PLAN AND PROFILE OF PROPOSED

17TH STREET
FROM GROVE TO HILLSIDE

CORNEJO & SONS/W B CARTER - CONTRACTOR
J. WAGNER - FIELD PROJECT ENGINEER, CITY OF WICHITA
J. JASO & J. SMITH - INSPECTORS, CITY OF WICHITA
AS-BUILT
RELEASE DATE:
:PDF APRosas 3/25/2011

**Sanitary Sewer
Line 1**
SHEET TITLE
87 N-0349-01
PROJECT NUMBER

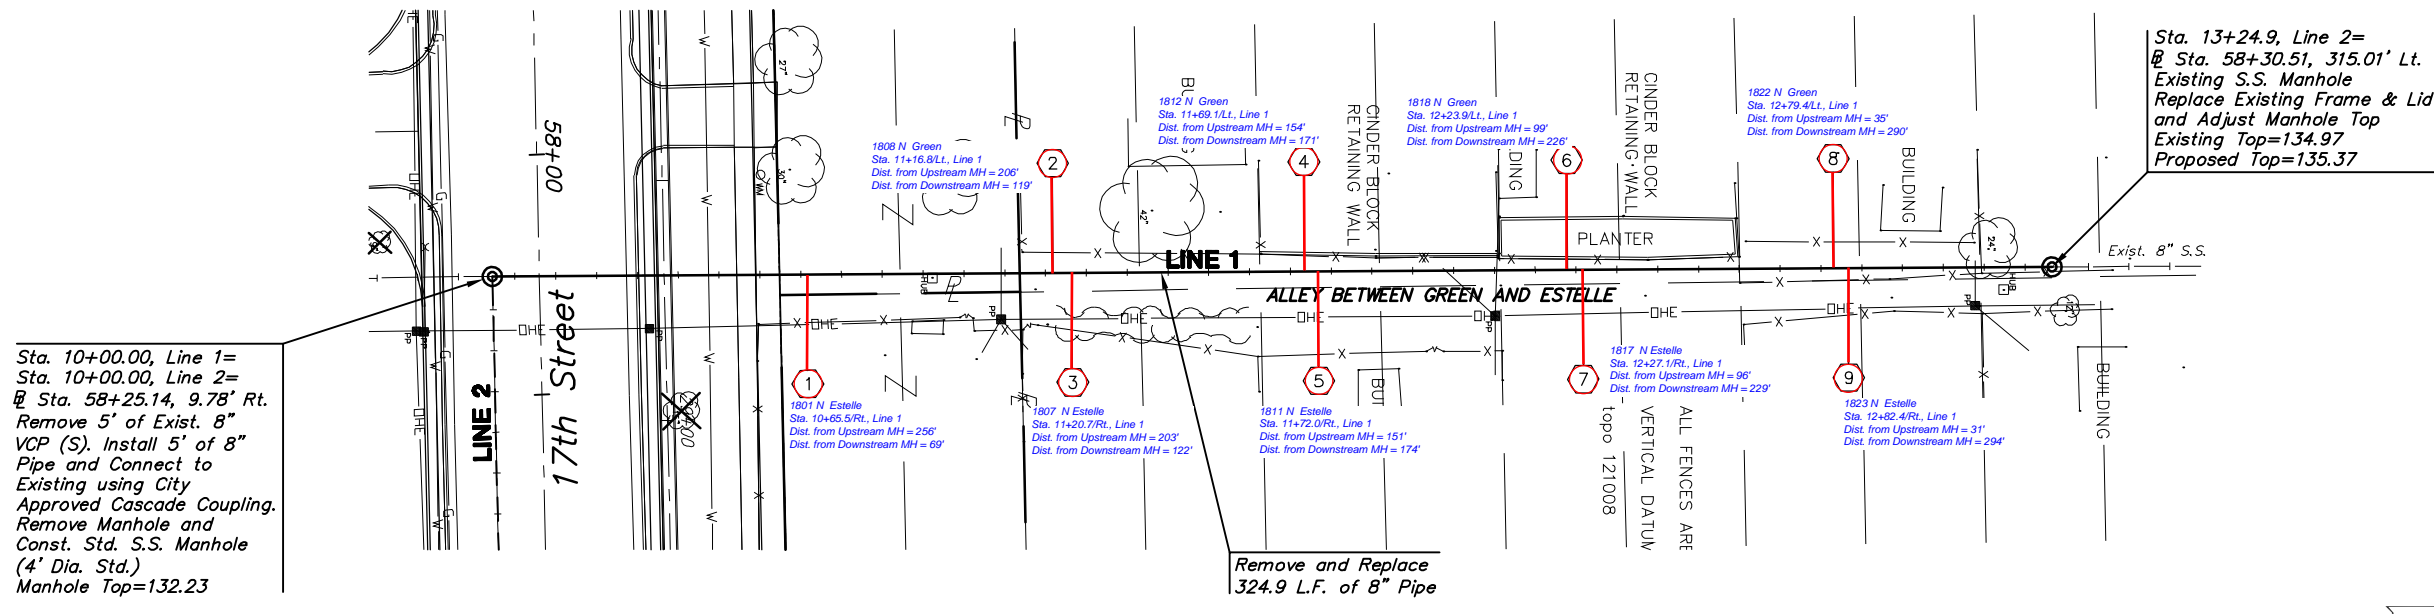
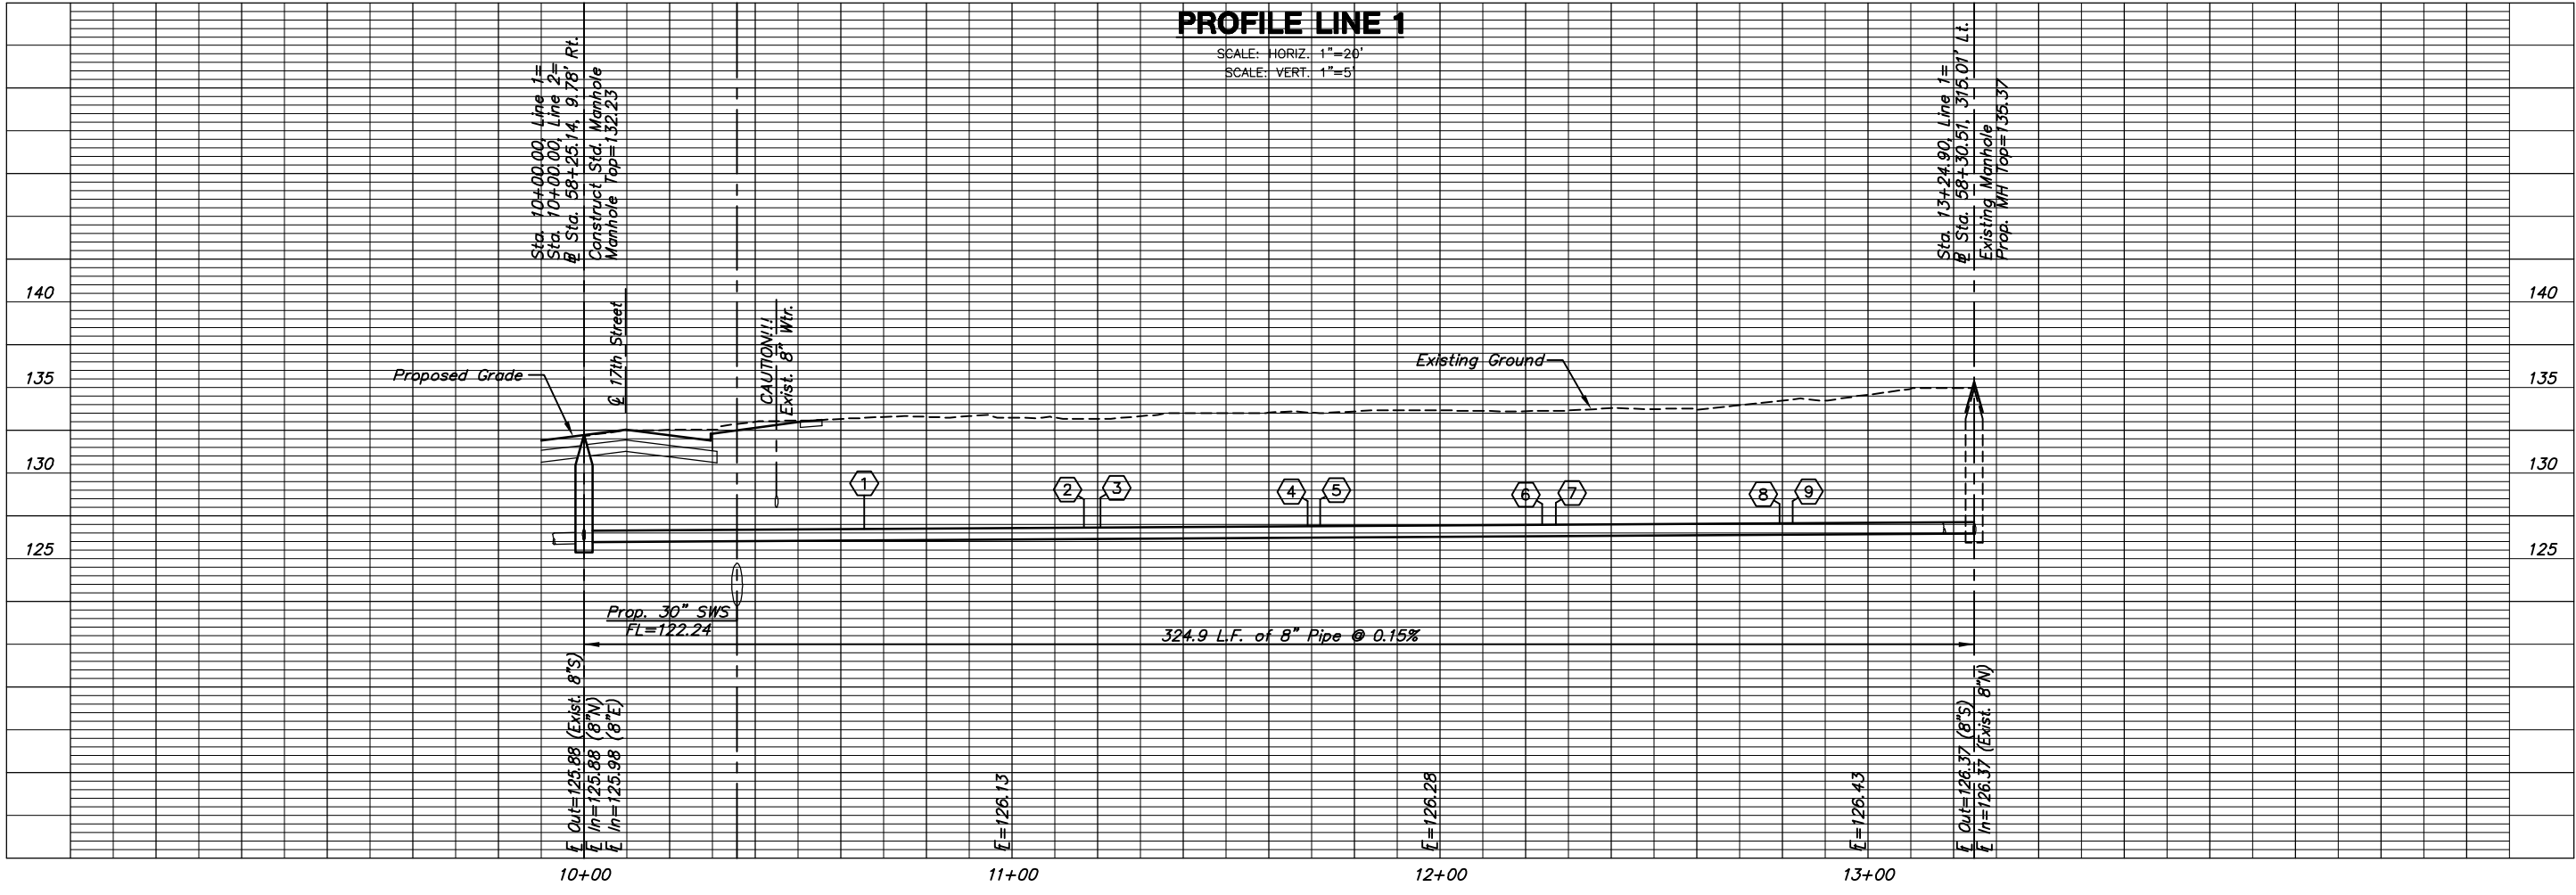
Built per plan

**Sanitary Sewer
Line 2**
SHEET TITLE
87 N-0349-01
PROJECT NUMBER

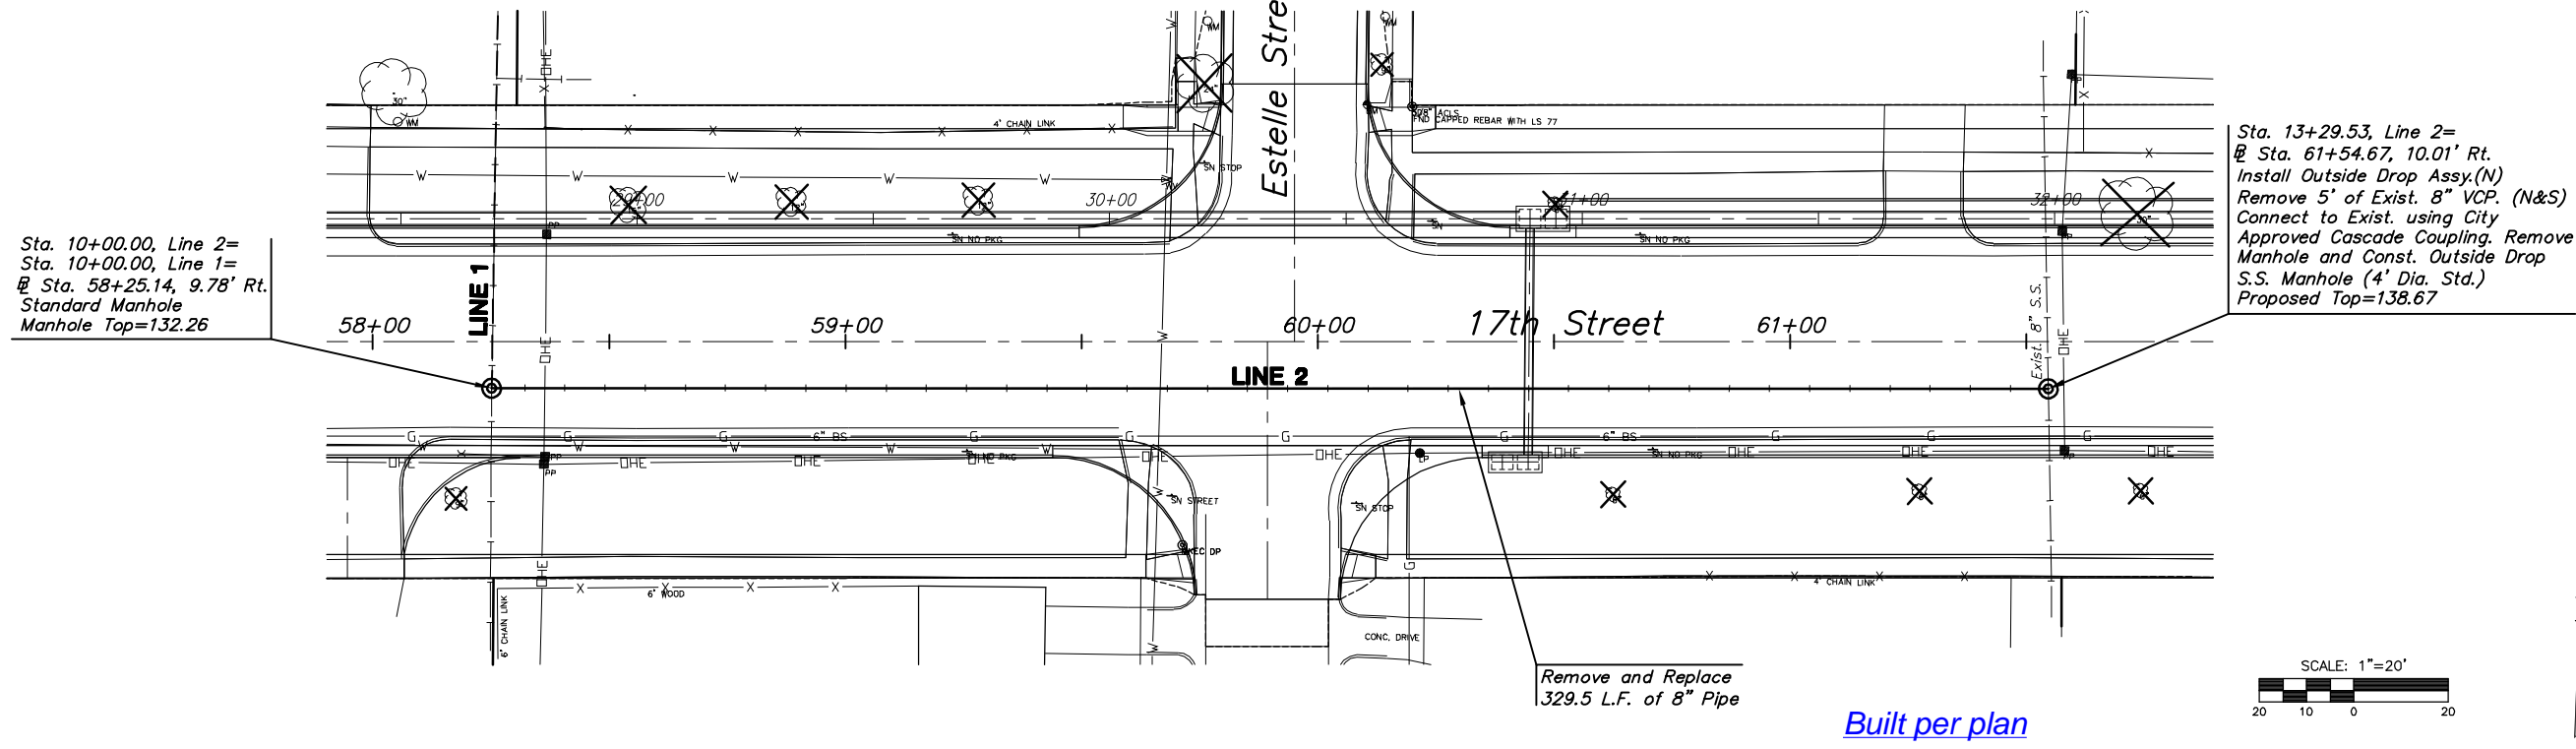
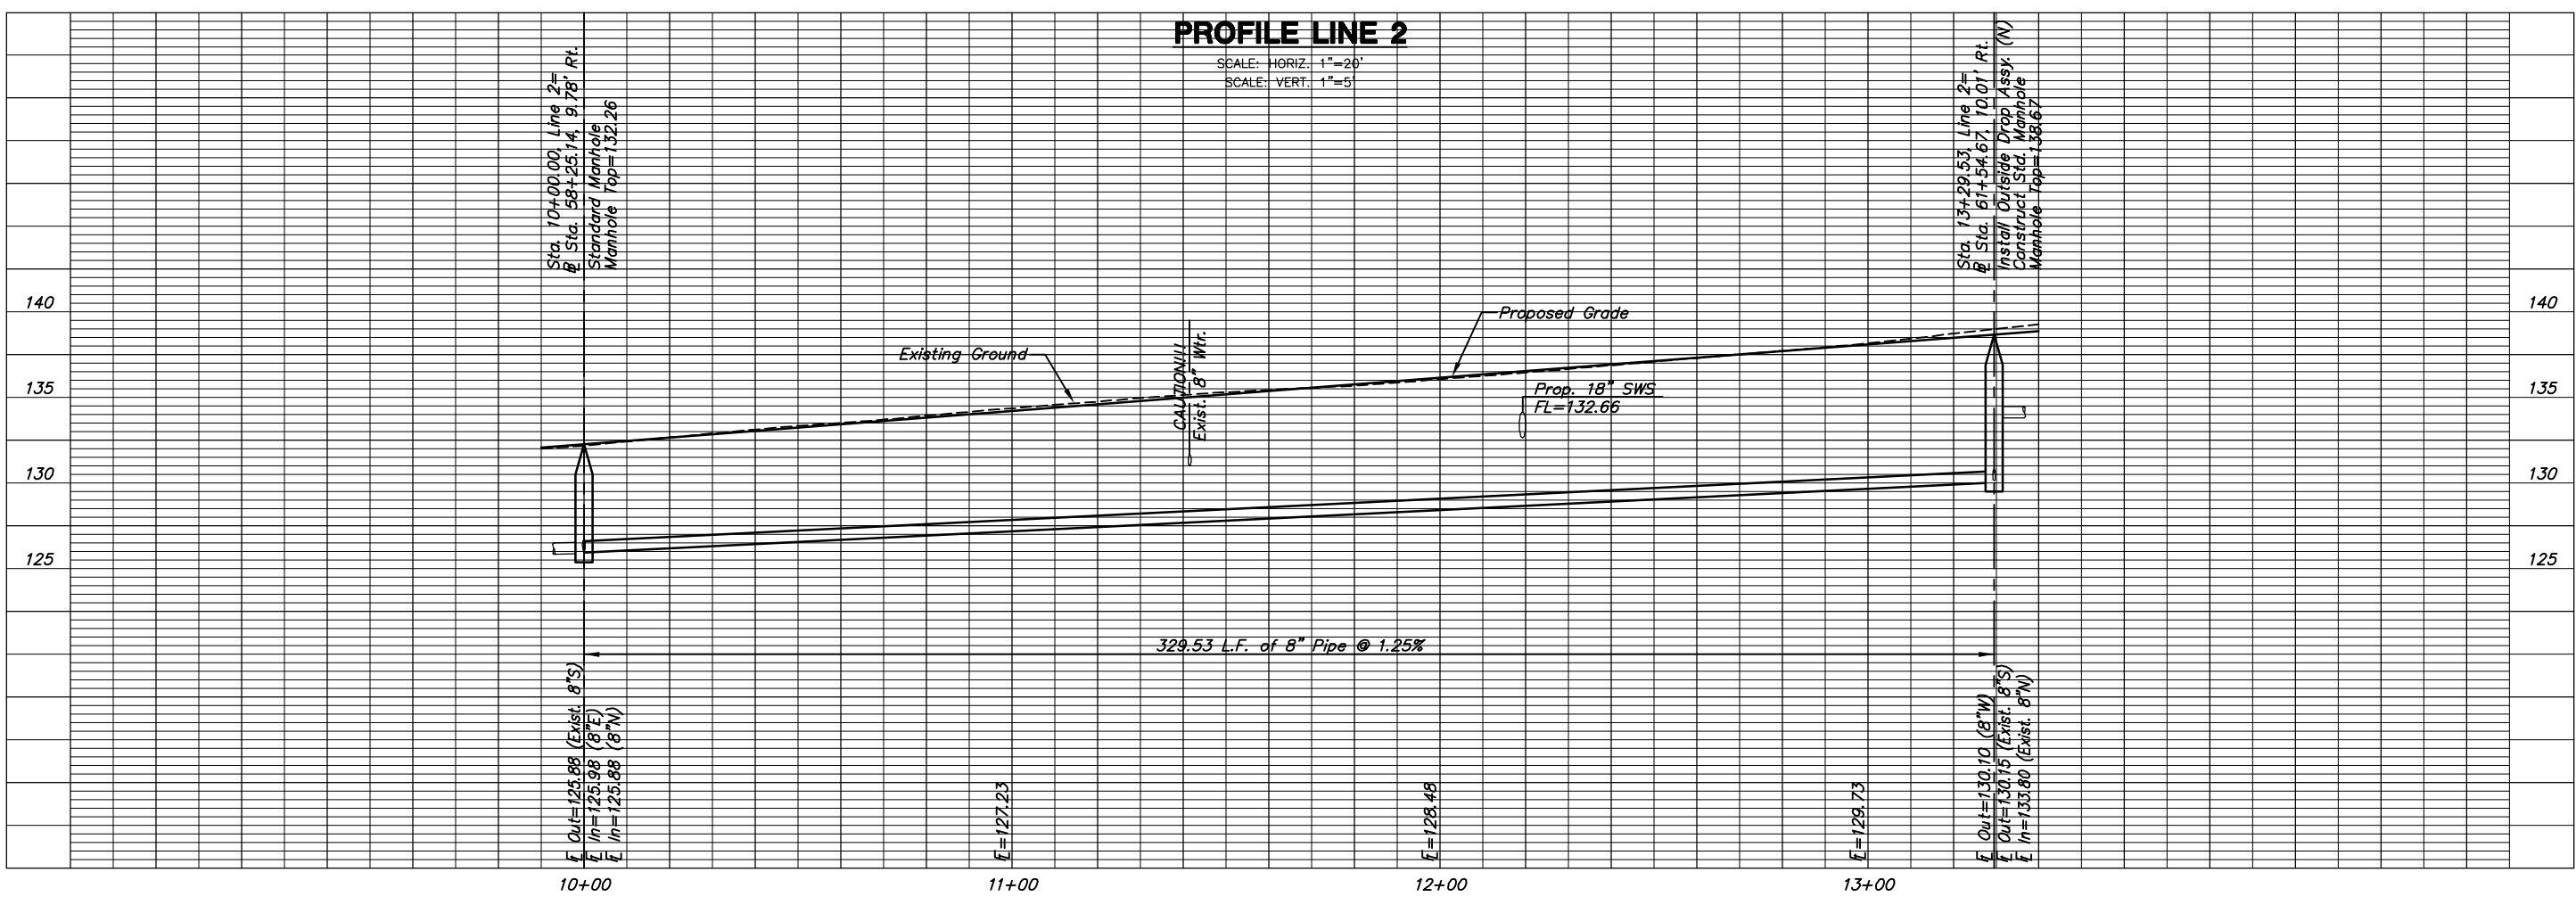
Built per plan
